DEPARTMENT OF TRANSPORTATION
HIGHWAYS DIVISION

ELECTRICAL SYMBOLS

North-South Road <u>Phase 1C</u> F.A.I. Proj. No. STP-8930(4)

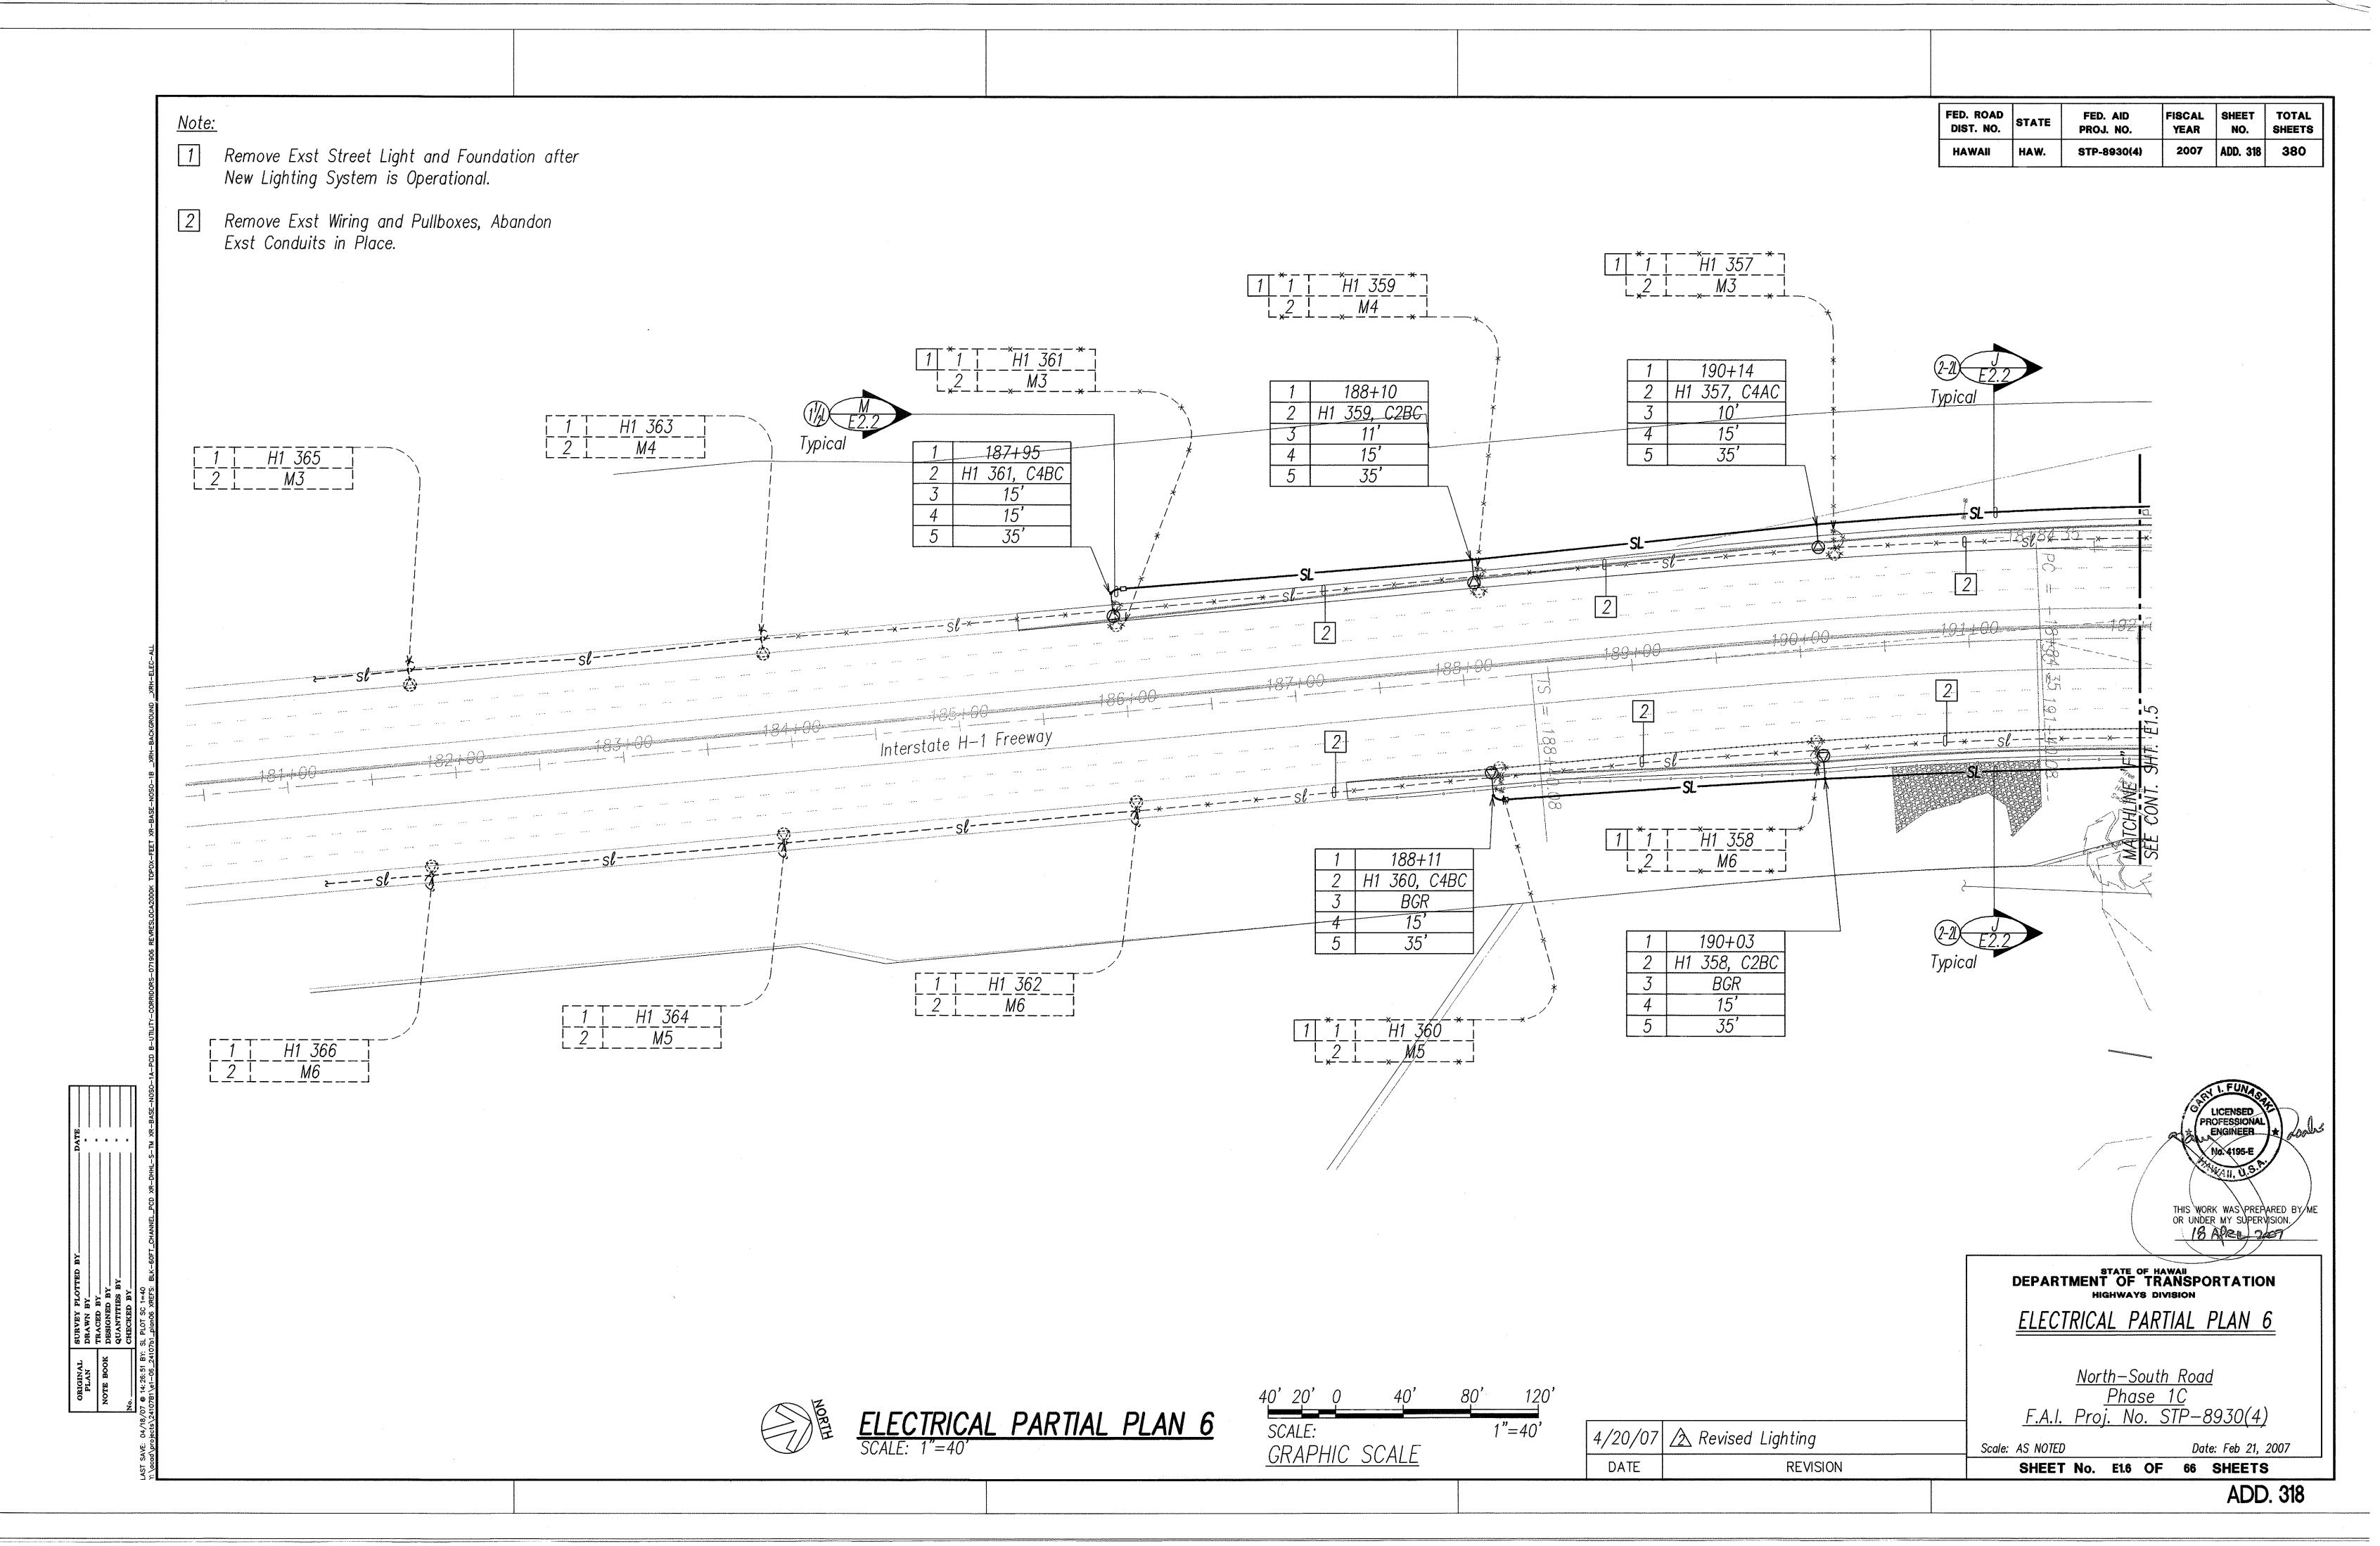
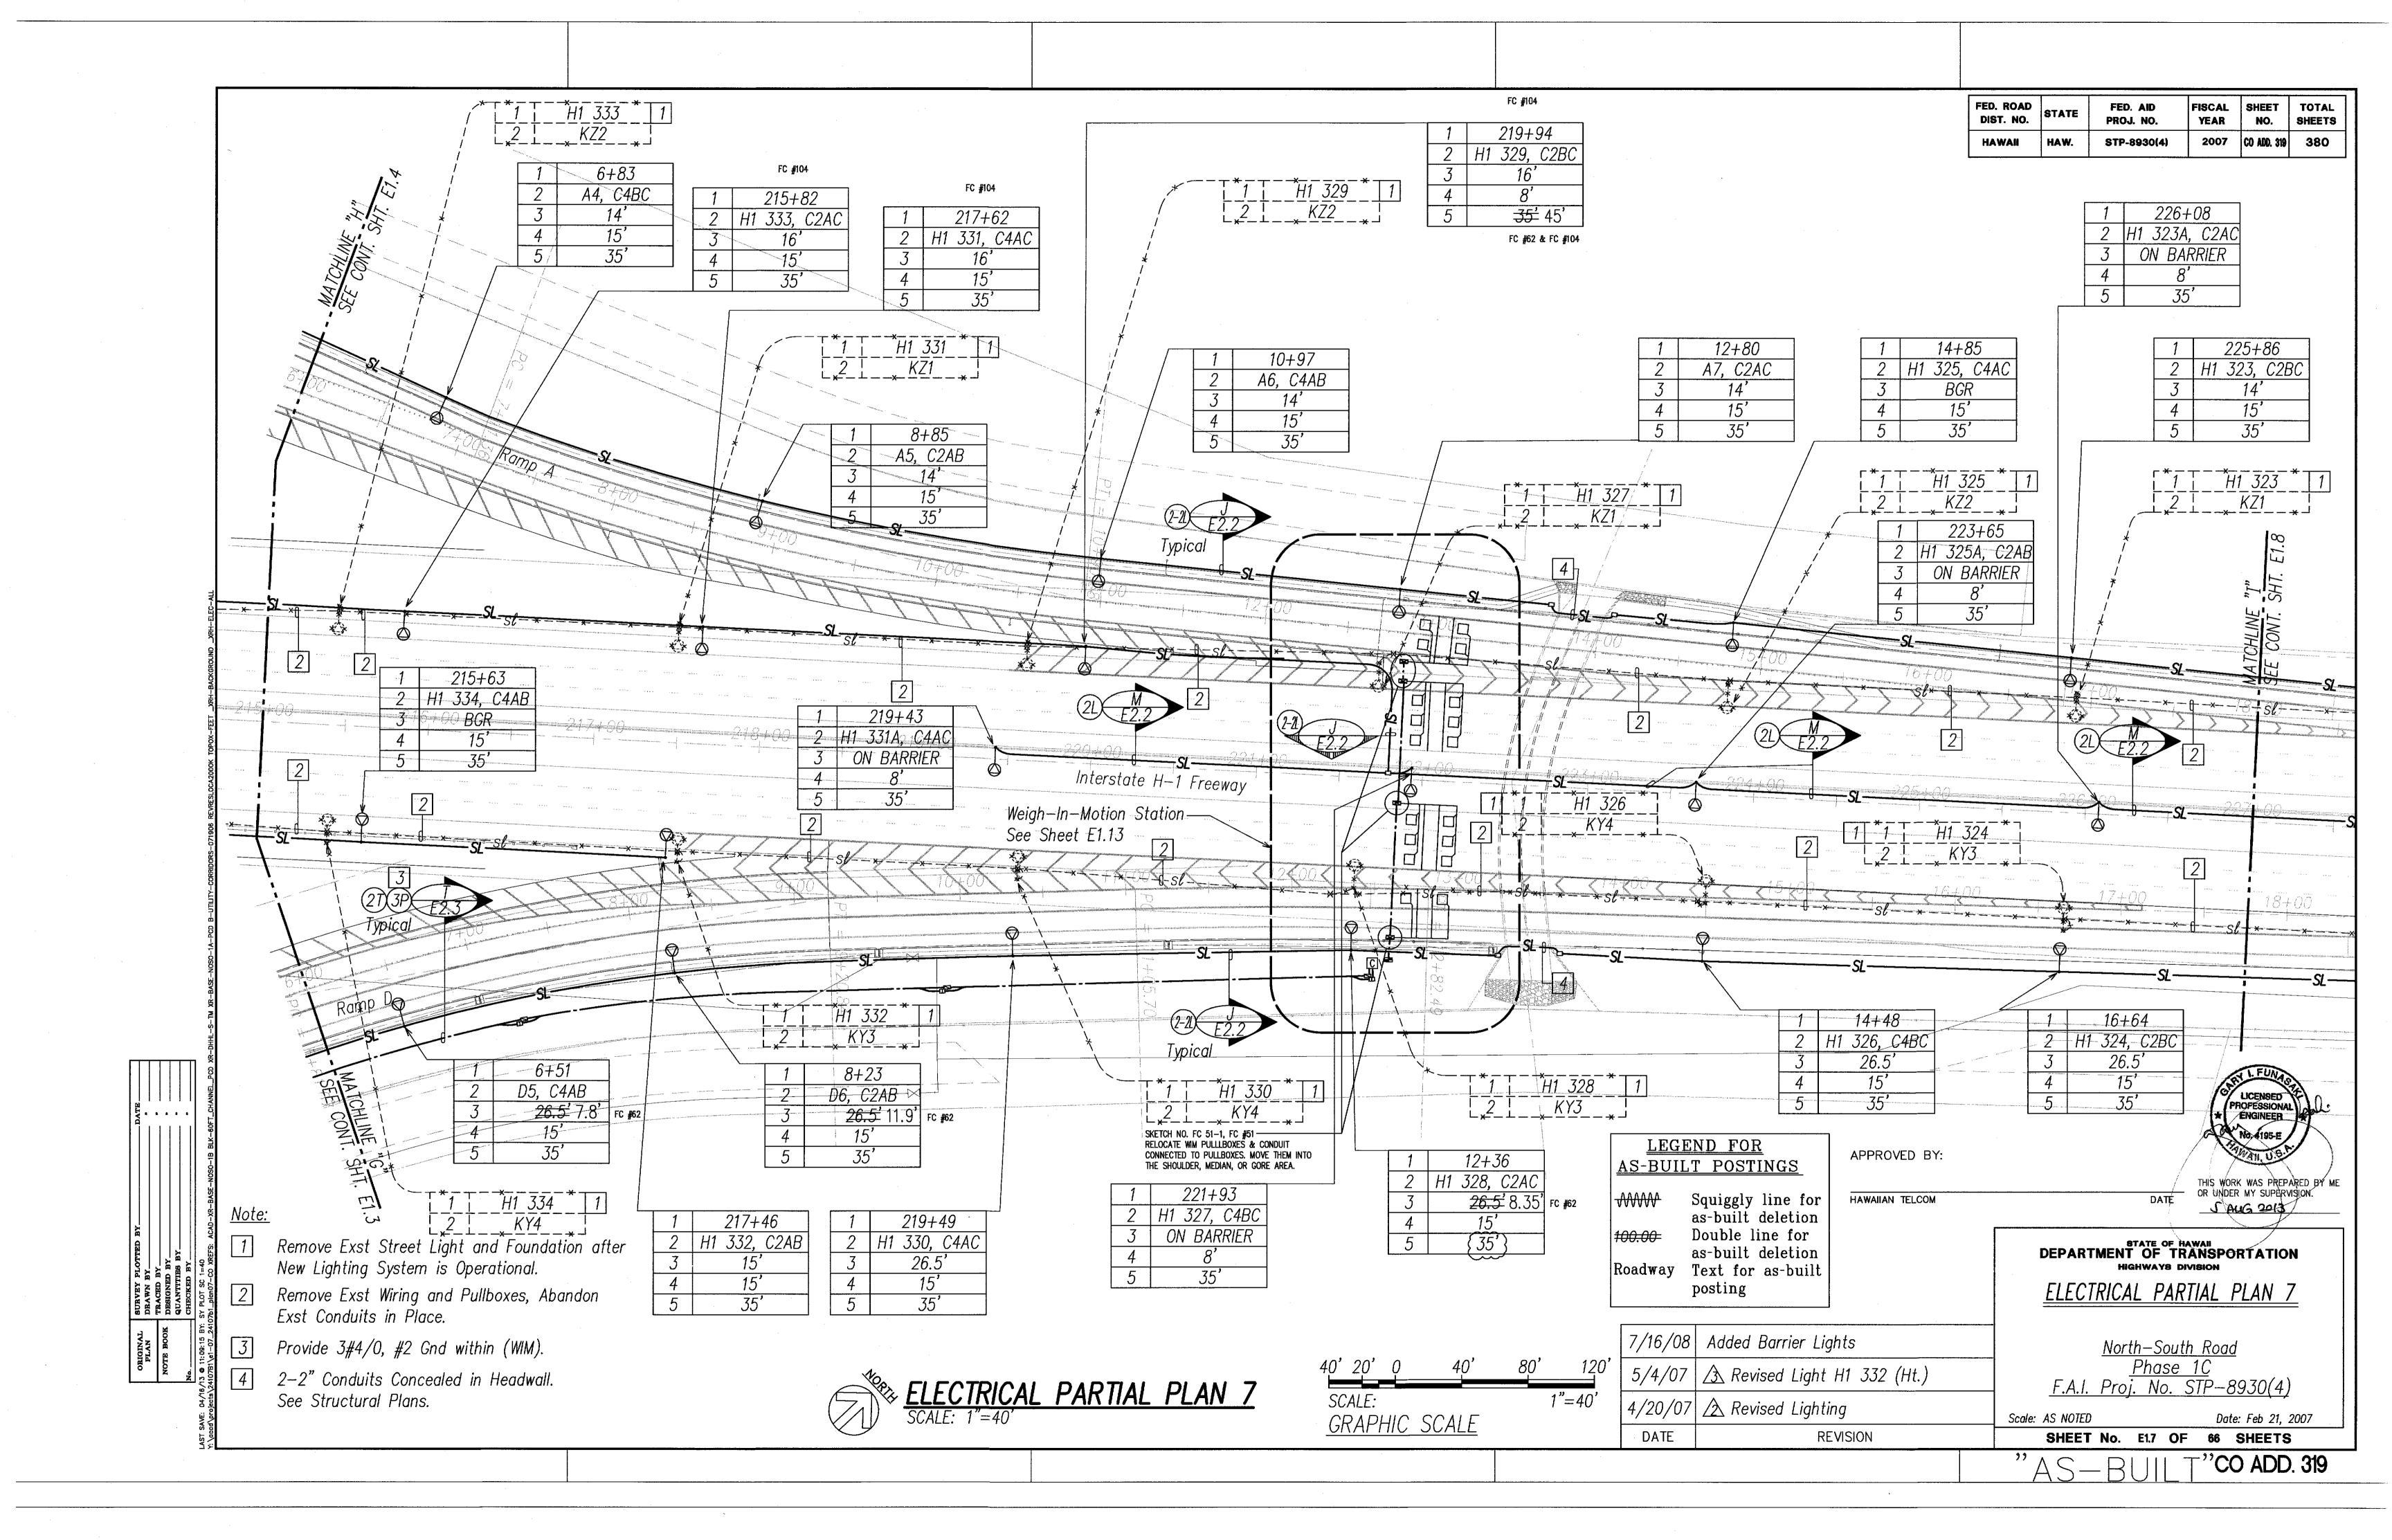
FC #144
TYPE B PULLBOX ELIMINATION ACCEPTABLE © STA 208+14 IF: ALL 3 PHASE OF CIRCUIT C2 SHALL BE EXTENDED INTO THE LIGHT STANDARD TRANSFORMER BASE

• UNCONNECTED PHASE OF CIRCUIT TO BE TERMINATED & CAPPED. RELOCATION OF CABLE SPLICING TO TRANSFORMER BASE OF HWY LIGHT H1 • 2" CONDUIT TO BE ADDED FOR FUTURE CIRCULIT EXTENSION. SPARE CONDUIT TO BE DIRECTED TOWARD PALEHUA BRIDGE, EXTENDING MIN. DISTANCE OF 5' FROM LIGHT STD FOUNDATION. (2-25) (4S) (2P) (2-2E) H1 341\* \_\_\_\_M3\_\_ FED. ROAD FISCAL SHEET TOTAL YEAR NO. SHEETS FED. AID DIST. NO. PROJ. NO. 213+80 211+97 206+39 -MATCHLINE "C" 2007 ADD. 315 380 IIAWAH HAW. STP-8930(4) H1 335, C4AB 2 H1 337, C2AB H1 341, C2BC SEE CONT. SHT. E1.4 H1 343 Remove Exst Street Light and Foundation after New Lighting *35*′ *35*′ 204+54 System is Operational. 2 H1 343, C4AC 2 Remove Exst Wiring and Pullboxes, Abandon Exst Conduits in Place. *35*′ Provide 12 Pr #20 Interconnect Cable \* \* - + - × - instance \*2 Conduist -208+19 131+53 131+53 Provide 3#1, #2 Gnd within (TS). 210+19 2 H1 339A, C2AB REVISED STATION FC #158 210+19 2 NS 33, C4AC **Underpass** NS 34, C2AC 2 H1 340, C2AC Provide 3#4/0, #2 Gnd within (WIM). 2 H1 339, C4AC H1 344 BSW 12<del>9</del>+60 M5 NS 32, C4AC BSW Interstate H-1 Freeway FROM UNDER PASS LIGHTING JUNCTION BOXES, UNDER BRIDGES, H1 335<sup>^</sup> ADJ. HWY = GRS CONDUIT, EXPOSED 204+54 ONDUIT TO BURIED ENCASED (CONCRETE)  $C^*$ CONDUIT = SCH 40 PVC. 2 H1 344, C2BC H1 342\* 206+39 208+19 2 H1 342, C4AB 2 H1 340A, C4BC 1 H1 336\* 2 KY3 \* H1 338 15' 213+80 2 H1 336, C2BC 126+60 128+20/ 1 1 H1 340 / 1/20 -211+97 NS 31, C2AC NS 30, C2AB 128+20 2 H1 338, C4BO M5\_/\* BSW BSW NS 29, C4AB 15 15' BSW TR Ace-141 (Pk Nail) Elev=203.00 35' 0+91 D1/D2, C4AB (-)5+22 C4, C4AC 4+65 D4, C2BC (-)1+14(-)3+50 C1, C2AB C3, C2AC BC 16'/ 35' 2+73 15'/ D3, C4BC 35'/ 126+80 (FC #65: 1ST. SUPPLEMENT) -1+91 O/S 55' (FROM BASELINE) NS 28, C4AB -1-4 126+80 BSW C2, C4AB Exst Palehua Raod 2 NS 27, C2/AB APPROVED BY: BSW/ HAWAIIAN ELECTRIC COMPANY, INC. /35' THIS WORK WAS PREPARED BY ME OR UNDER MY SUPERVISION. LEGEND FOR HAWAIIAN TELCOM AS-BUILT POSTINGS 125+40 DEPARTMENT OF TRANSPORTATION
